# Technical Newsletter

## DDS2300 (FIR Specification): Notice of FIR Heater Change (Heat Expansion Upper Section)

DDS2300 (FIR specification)

FIR heater before and after the change

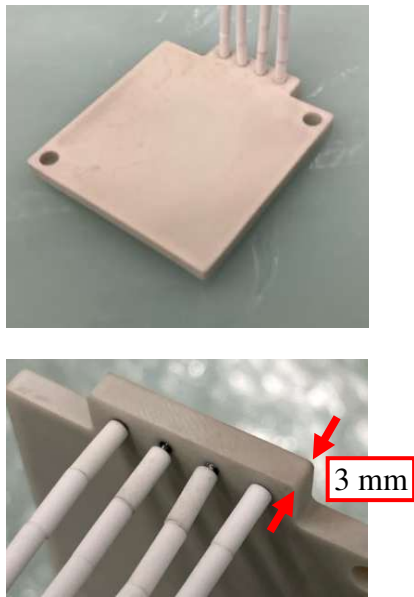
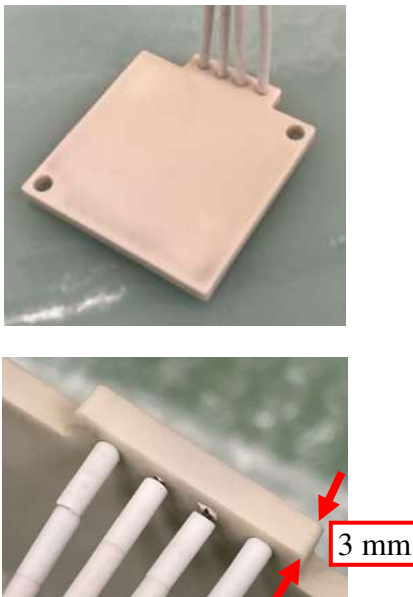
Due to discontinuation, the FIR heater (3 mm thickness) in the heat expansion section will be changed. It has been confirmed that the shrink performance of the tape before and after the change is comparable (see next page). In addition, a user-specified specification to improve shrink performance of the tape is currently under development. If you have any concerns regarding processing quality after replacing the heater, please contact us for support.

Before	After
Parts No.	LKWD-160001-*	LKWD-160013-*
Appearance		
Material	Ceramic	Ceramic
Purpose	Heat shrinking of tape	Heat shrinking of tape
Other	Fixing of cable section Brazing	Fixing of cable section Changed to potting with adhesive.

From January 2027 onward; upon depletion of LKWD-160001-\* stock.

Kerf width after workpiece processing

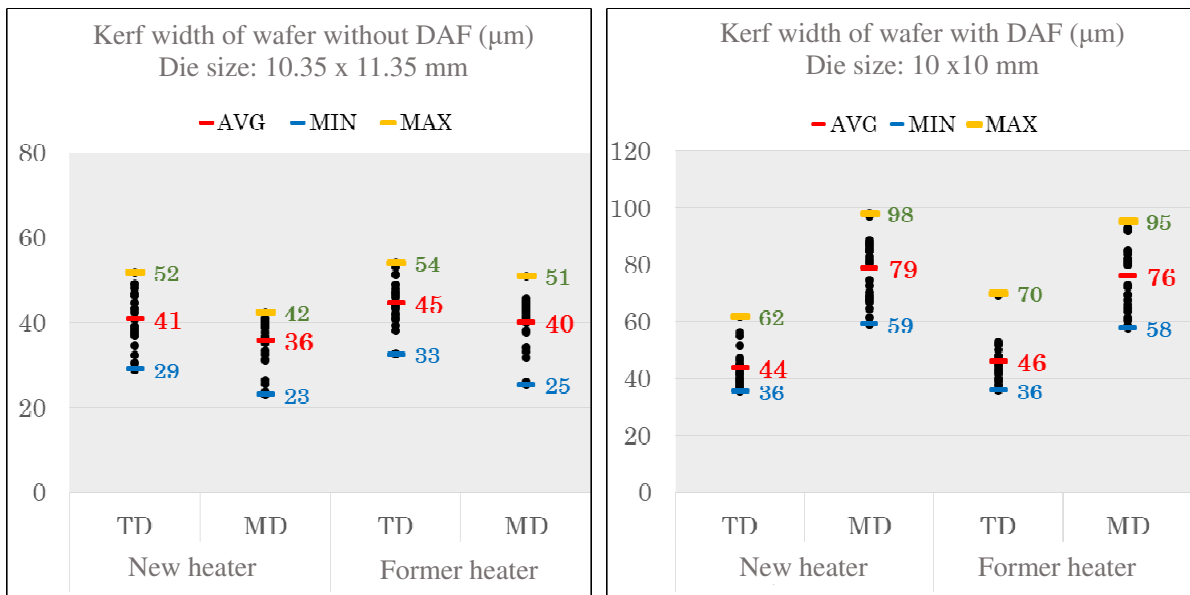
These are reference values of kerf width measured after processing workpieces using the DDS2300 (FIR specification) equipped with the former and new heaters, respectively.
